ILC 1X1 – CHANGE NOTES

Change notes for ILC 1X1 Inline controllers

Application note
105625_en_07

Current firmware version: 4.60

Figure 1 Modbus/TCP servers in the PC Worx Bus Structure

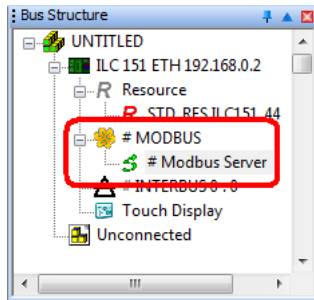
Type ILC 1X1 controllers can now also be configured as Modbus/TCP servers.

Each controller supports a different number of communication connections to the Modbus/TCP clients:

Figure 2 Selecting SD card functions

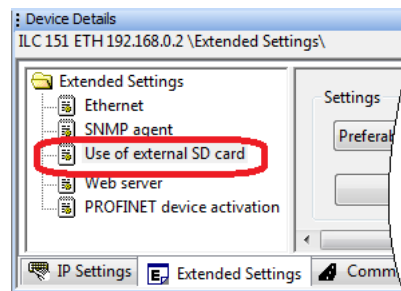
The SD card's functionality has been extended. The SD card can now be used either as the main memory or as additional memory.

As additional memory, the SD card can be used for storing log files.

You can select the SD card functions you need in the "Device Details" window in PC Worx.
